G-04512
August 2004

**SUBJECT: SAFETY RECALL INTERIM ACTION (U.S., EXPORT)
POWER STEERING HOSE ROUTING, ENGINE
HARNESS ROUTING and OIL PRESSURE SWITCH
on certain MODEL YEAR 2005 RE BUS models built
3/3/2004 thru 8/5/2004 with I6 engines only.**

Figure 1

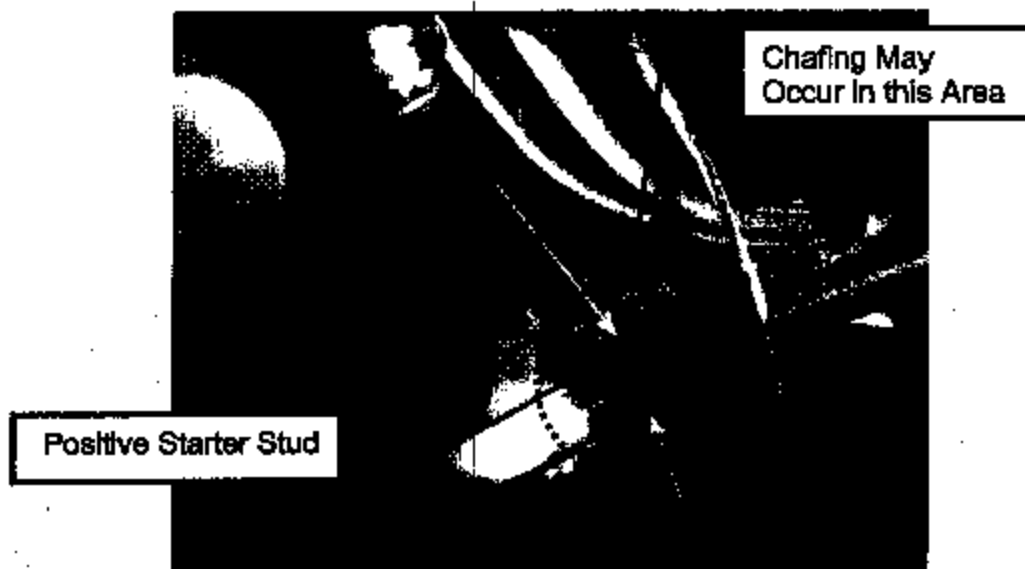
1. Inspect power steering hose for chafing damage in area near where it may have been in contact with the positive stud of the starter solenoid.

2. If any chafing has taken place, replace power steering hose, refill reservoir AND install conduit and strap-locks as indicated below.
3. Install conduit onto power steering hose. Ensure conduit runs from power steering pump to at least forward of bell housing, or clear of engine block.

Figure 3

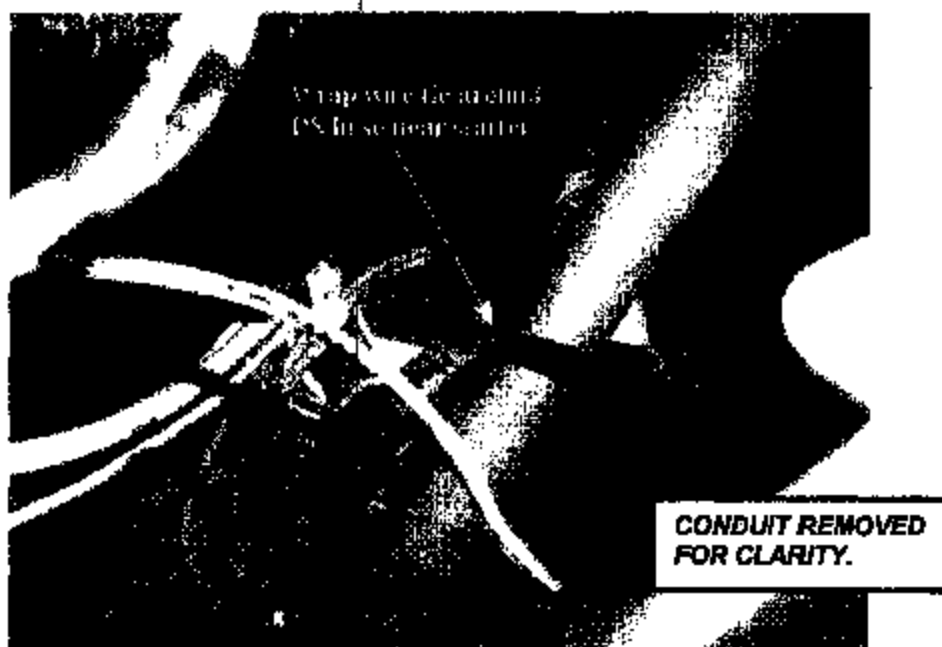
5. Wrap strap-lock around power steering hose near starter.

Figure 4

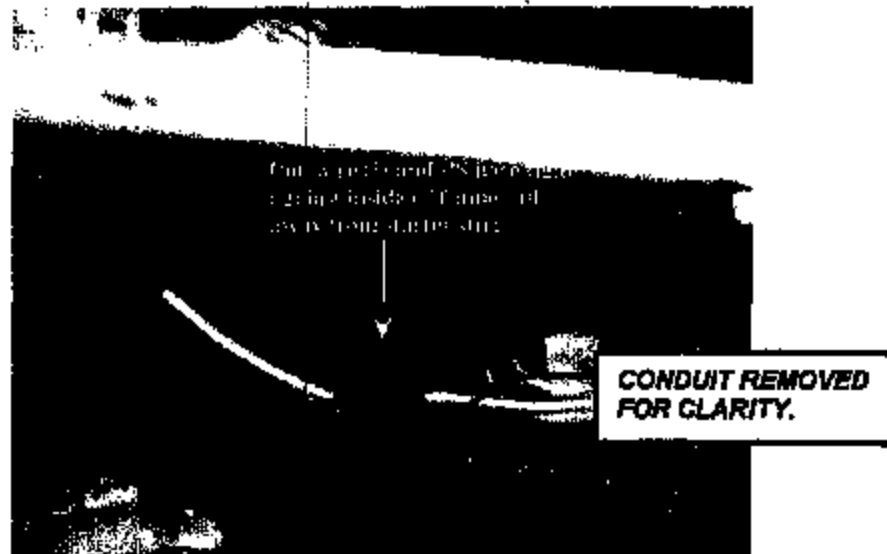
6. Pull strap lock and hose tight against the inside of the frame rail away from the starter solenoid. Make sure the convoluted tubing is protecting the P/S hose at frame contact areas.

Figure 10

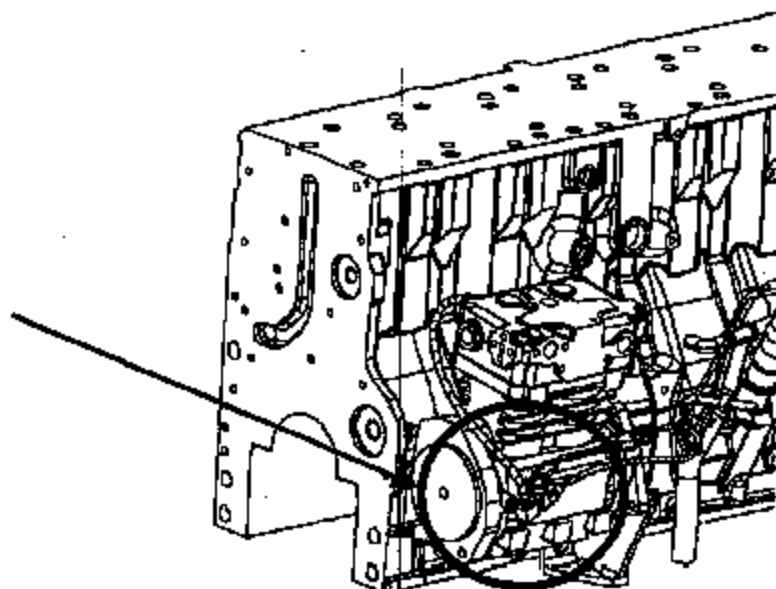
1. Locate, disconnect, and remove oil pressure switch. Please verify via lineset ticket that a bus requires (has) an oil pressure switch. (Feature Code **0008WPG** or **0016HJA**).

Figure 11

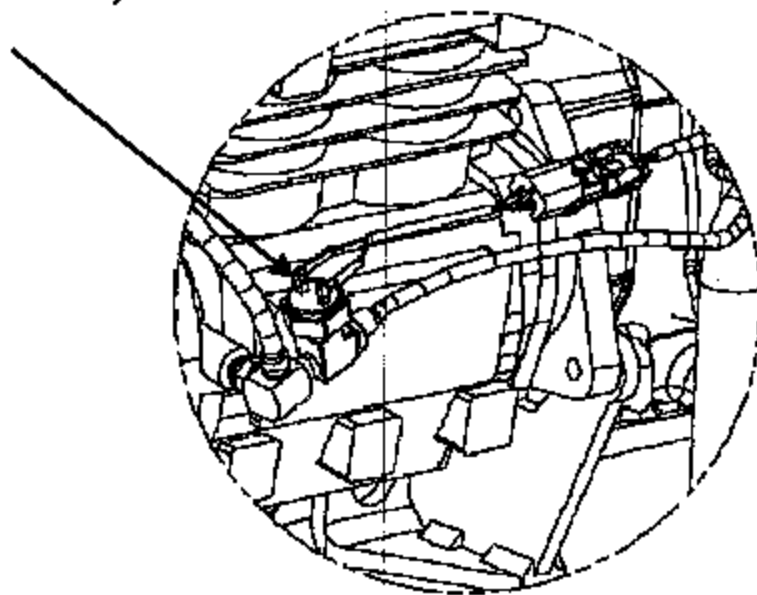
2. Install and connect new oil pressure switch. Refill oil reservoir if necessary.
